Access Compliance Report

Public Rights-of-Way

(Pedestrian Signals)

Intersection ID: N/A	Main Street:	Cross Street: N/A	Location: N/A
ADA ID: 47F24067B22D	Signal Type: Two Push Buttons-APS	Overall Compliance: No	Severity Score: BTN 1:N/A BTN 2: N/A No BTN: N/A
Codes/Mitigation Info/Possible Solution		Field Measurements/Component Compliance

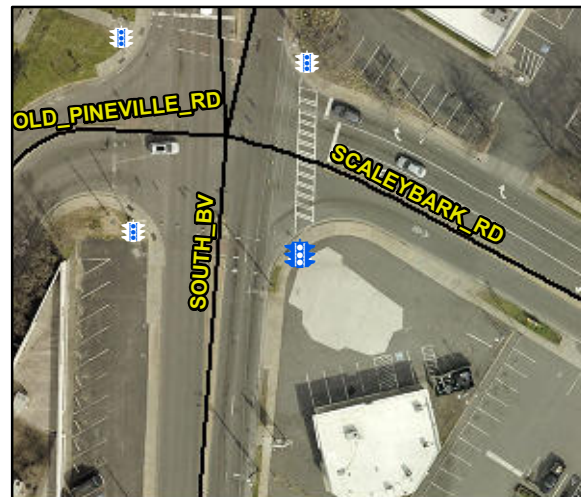
Compliance	Description	Data	Compliance	Description	Data
	Button Count	Button2	N/A	Distant to Additional Button (in)	N/A
	Additional Button Present?	No		Additional Button ID	N/A
N/A	Signal Buttons Required?	N/A	N/A	Additional Ped Posts Required	N/A
	How Many Ped Street Xings?	2		Located In An Island/Median?	No
N/A	B 1 Sign Present?	Yes	N/A	B 2 Sign Present?	Yes
Yes	B 1 Sign Purpose?	Yes	Yes	B 2 Sign Purpose?	Yes
Yes	B 1 Sign Lettering & Contrast?	Yes	Yes	B 2 Sign Lettering & Contrast?	Yes
Yes	B 1 Parallel To XWalk?	Yes	Yes	B 2 Parallel To XWalk?	Yes
Yes	B 1 PAR to Button?	Yes	Yes	B 2 PAR to Button?	Yes
Yes	B 1 PAR to XWalk?	Yes	Yes	B 2 PAR to XWalk?	Yes
Yes	B 1 Clear Floor Space?	Yes	Yes	B 2 Clear Floor Space?	Yes
N/A	B 1 FWD Approach?	Yes	N/A	B 2 FWD Approach?	Yes
N/A	B 1 FWD Approach Constrained?	No	N/A	B 2 FWD Approach Constrained?	No
No	B 1 FWD Approach Reach (in)	10.0	No	B 2 FWD Approach Reach (in)	13.0

N/A	B 1 FWD Approach Width (in)	N/A	N/A	B 2 FWD Approach Width (in)	N/A
N/A	B 1 FWD Approach Obstruction?	Yes	N/A	B 2 FWD Approach Obstruction?	Yes
N/A	B 1 FWD Approach Obstruction Dist (in)	8.0	N/A	B 2 FWD Approach ObstructionDist (in)	13.0
N/A	B 1 PARA Approach?	Yes	N/A	B 2 PARA Approach?	Yes
N/A	B 1 PARA Approach Constrained?	No	N/A	B 2 PARA Approach Constrained?	No
Yes	B 1 PARA Approach Reach (in)	8.0	Yes	B 2 PARA Approach Reach (in)	10.0
N/A	B 1 PARA Approach Width (in)	N/A	N/A	B 2 PARA Approach Width (in)	N/A
N/A	B 1 PARA Approach Obstruction?	Yes	N/A	B 2 PARA Approach Obstruction?	Yes
N/A	B 1 PARA Approach Obstruction Dist (in)	8.0	N/A	B 2 PARA Approach ObstructionDist (in)	8.0
Yes	B 1 Clear Floor Space Slope (%)	4.5	No	B 2 Clear Floor Space Slope (%)	4.9
No	B 1 Clear Floor Space XSlope (%)	3.4	No	B 2 Clear Floor Space XSlope (%)	2.5
N/A	B 1 PAR Slope (%)	5.6	N/A	B 2 PAR Slope (%)	3.5
Yes	B 1 Height (in)	33.0	Yes	B 2 Height (in)	35.0

Yes	B 1 Clear Xing Direction?	ClearlyMarked	Yes	B 2 Clear Xing Direction?	ClearlyMarked
	B 1 Crossing Direction	To N		B 2 Crossing Direction	To W
Yes	B 1 DistanceTo XWalk (in)	0.0	Yes	B 2 DistanceTo XWalk (in)	0.0
No	B 1 DistanceTo Curb (in)	110.0	No	B 2 DistanceTo Curb (in)	110.0
Yes	B 1 Diameter (in)	2.0	Yes	B 2 Diameter (in)	2.0

Possible Solutions: Replace Signal Push Button With APS Button on New Post. Remove & Relocate Sign.

PROW/ADA: TMUTCD 4e.08, R404.2, R406.2, , R404.3
